UNITED STATES PATENT AND TRADEMARK OFFICE

APPLICATION NO.	FILING DATE	FIRST NAMED INVENTOR	ATTORNEY DOCKET NO.	CONFIRMATION NO.
10/661,342	09/12/2003	Robert Paul Dressler	16466-US	8045

Office Action Summary

FIG. 4

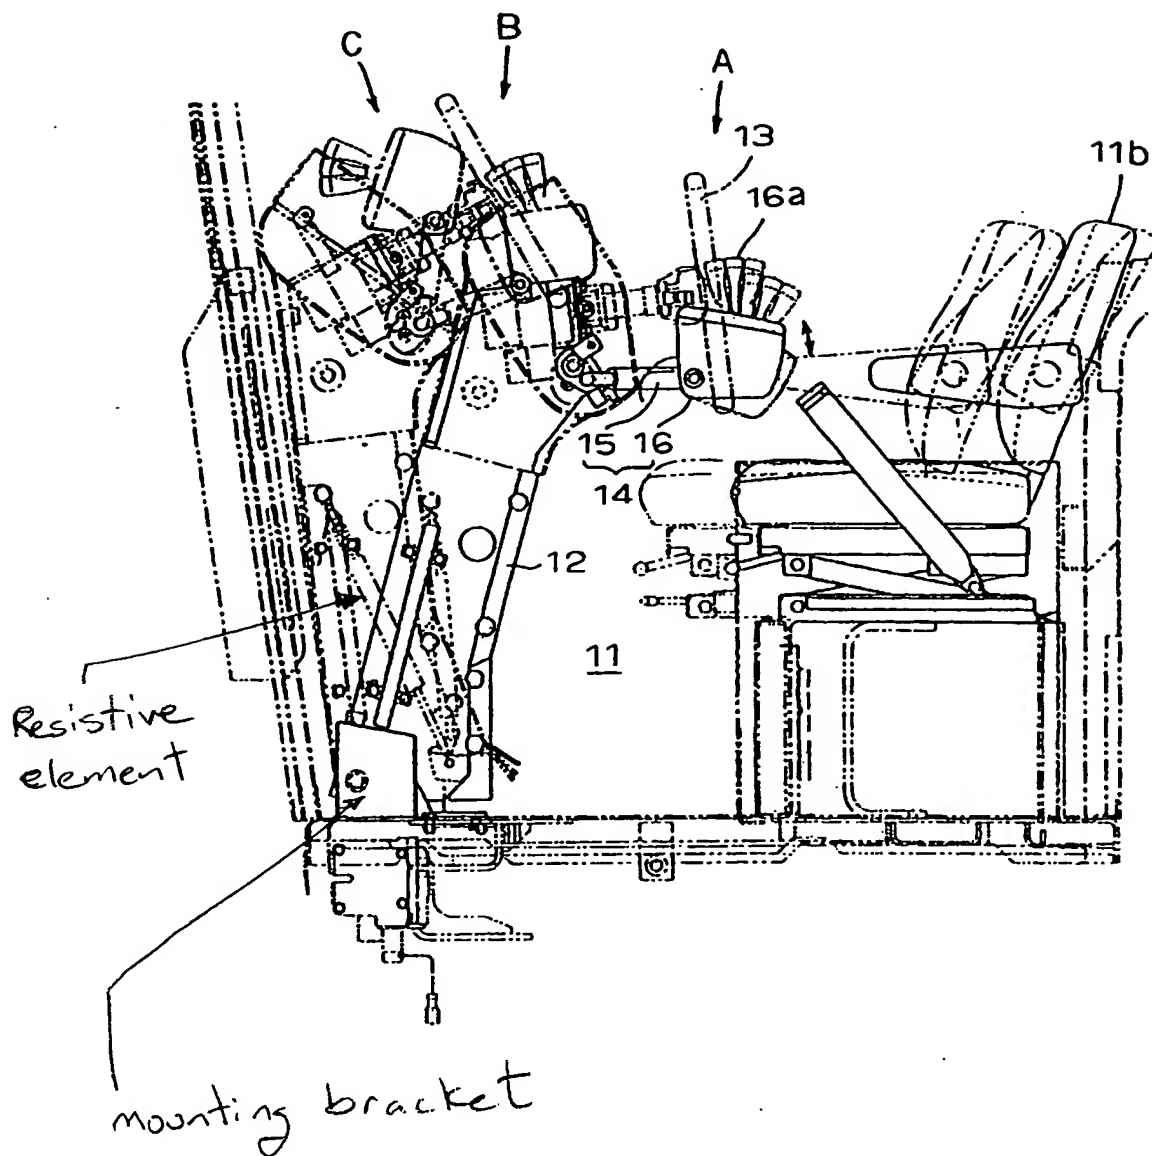
Nishimaki discloses a latchless controller positioning system including a mounting bracket (not numbered but shown in figure 4 (see also attached modified fig. 4), a control tower 12, a controller assembly 14, a resistive element not numbered but shown as a strut in broken lines in figure 4 (see also attached modified fig. 4) mounted to the controller tower and mounting bracket to provide a toggle effect as shown in figure 4.

Nishimaki discloses a controller positioning system for a work vehicle as described previously, but lacks specifying that the shown strut is a gas filled strut.

art would have found it obvious to substitute the gas filled strut of Volpel for the unspecified strut of Nishimaki.
